AMENDMENT REQUEST  
STAFF REPORT AND PRELIMINARY RECOMMENDATION

Application No.: 6-03-41-A1

Applicant: California Department of  
Parks and Recreation

Amendment: Redesign sheetpile/shotcrete seawall on both the south and north sides, eliminate use of all toe-stone, redesign the north plaza area that lies between the north seawall and the parking lot, construct access stairs across northern seawall and relocate entrance road approximately 14 ft. south of approved location.

EXHIBIT NO. 2  
APPLICATION NO.  
**6-03-41-A1**

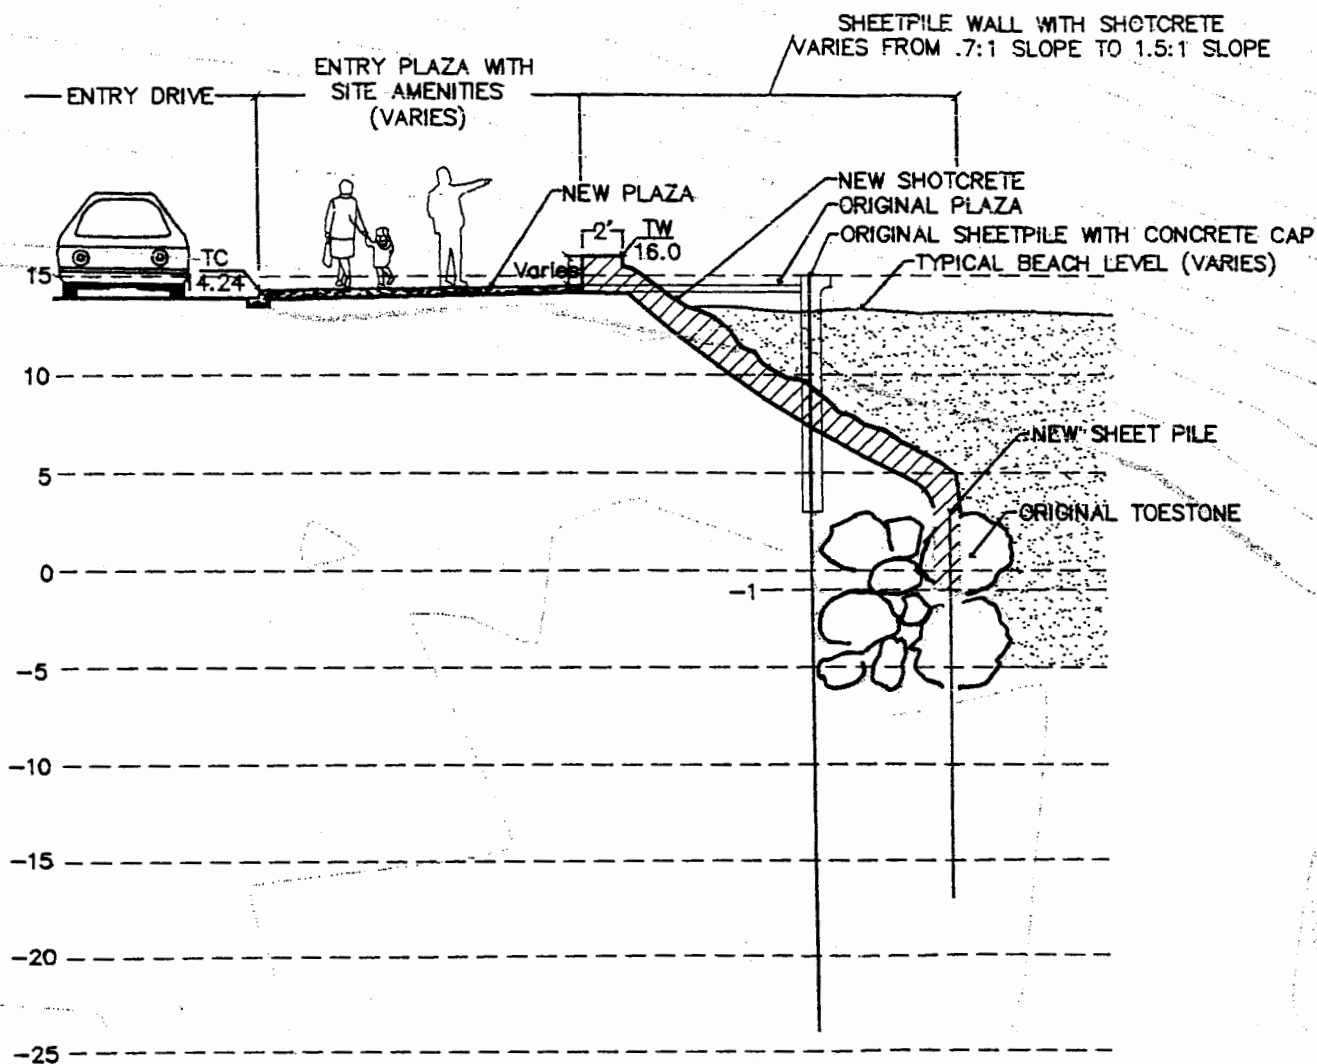
On the approximately 237 ft.-long, northern seawall, the applicant is proposing to more significantly redesign the seawall. The original proposal involved the use of approximately 40 ft. long buried sheetpiles with the upper 12 ft. of the sheetpile capped by a vertical concrete wall. The original approximately 237 ft.-long vertical seawall would have involved the placement of 1 to 5-ton toestone, approximately 7 ft. in height and extending for approximately 12 ft. seaward of the vertical seawall at elevations -4 ft. MSL (Mean Sea Level) to +3 MSL. Depending on sand and cobble levels, the toestone was expected to remain buried. However, since it was to be placed to a height of up to +3 MSL, it could potentially become visible and adversely affect public access across the beach. The applicant is now proposing a redesign which will eliminate all use of the

toestone. Instead of using 40 ft. long sheetpiles, the applicant is proposing to use approximately 17 ft.-long sheetpiles and design the upper portion of the wall in a similar fashion to the proposed southern seawall. As a result, the northern buried sheetpile wall will be located approximately 10 ft. seaward of the originally proposed wall (but no further seaward than the previously approved toestone that is no longer needed), with the top of the sheetpile to be located at approximately +3 MSL (instead of +15 ft. MSL) and capped by an approximately 12 ft.-high colored and textured sloping shotcrete wall. The shotcrete wall will slope back to the proposed plaza area on a slope that ranges from 0.7:1 to 1.5:1. Most of the proposed northern shotcrete upper wall will have a slope of 1:5:1. The more vertical 0.7:1 will occur adjacent to the existing sheetpile wall that contains an existing concrete cap with a slope of 0.7:1 (ref. Exhibit #3).

EXHIBIT NO. 3  
APPLICATION NO.  
**6-03-41-A1**  
Proposed Northern  
Wall Site Plan

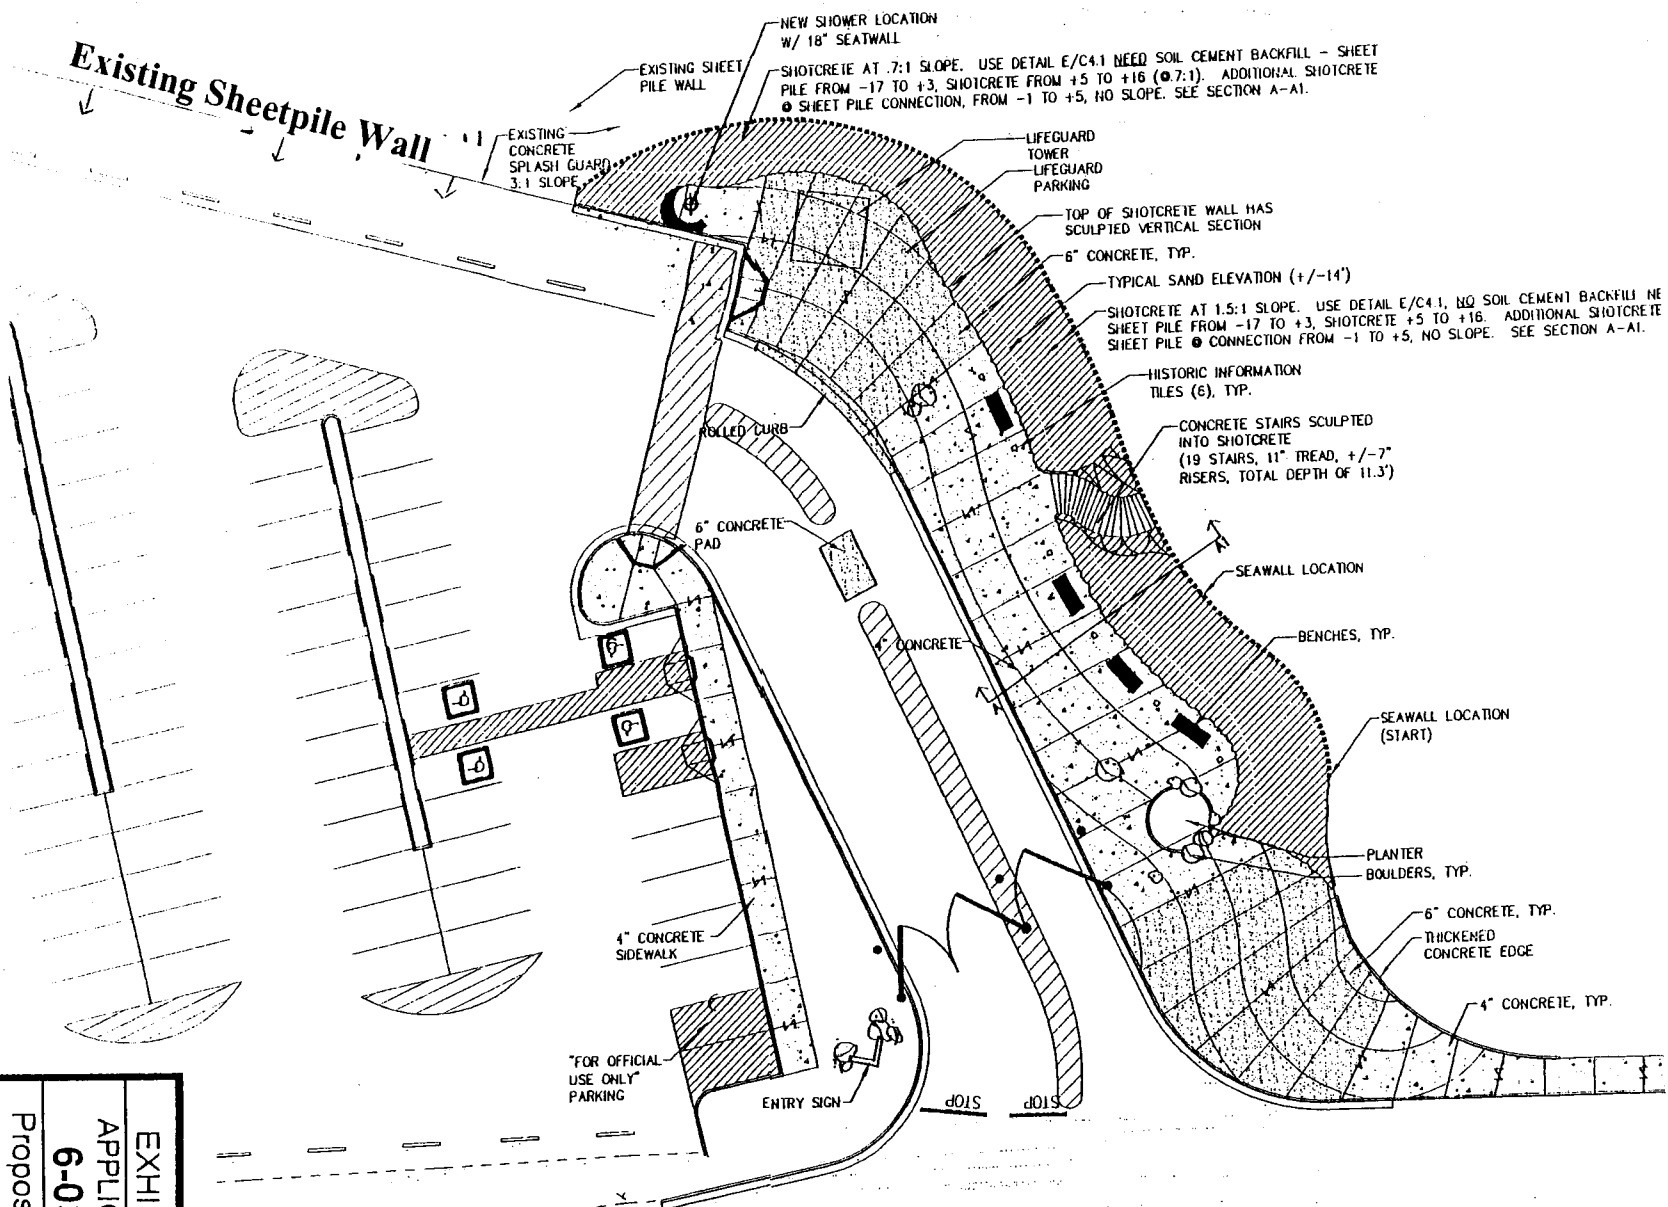
The concern raised by the redesigned northern wall is whether it will result in adverse impacts to geologic hazards, shoreline processes or public access over what was approved by the Commission in June of 2004. In this case, the impacts of the revised seawall are not substantially different than the approved design. While the northern sheetpile wall will be located approximately 10 ft. seaward of its earlier proposed location, the toestone element which was approved with the original design would have extended 12 ft. seaward of the first proposed sheetpile wall. Thus, the new seawall design will actually be 2 ft. landward of the toestone element thereby reducing the actual encroachment onto the beach over the originally approved design. The applicant has indicated that toestone is no longer necessary to support the seawall because of the design changes. The first design approved by the Commission involved a cantilevered wall with an embedment depth of -24 ft. MSL requiring toestone support to counteract forces pushing the wall over (seaward). The new design involves a shorter sheetpile wall that is supported by a concrete wall on top that slopes back and is attached to the proposed plaza area. The buried front wall provides wave protection, while the upper back wall provides protection to the front wall from overturning. More importantly however, both the originally approved design and the subject redesign will result in shoreline protection that is far more landward than currently exists. Currently rock riprap extends up to approximately 20 ft. from the existing park facility, 10 ft. further seaward that the proposed redesigned northern seawall. With the construction of the north and south seawalls and the removal of all rock riprap from the beach, more beach will become available for public use than currently exists.

- c. The northern concrete seawall above the proposed approximately 237 ft.-long northern sheetpile wall shall be designed to be visually treated to maximum extent possible so as to lessen its visual prominence. The visual treatment should closely match the visual treatment elements proposed for the southern shotcrete seawall to the maximum extent possible.
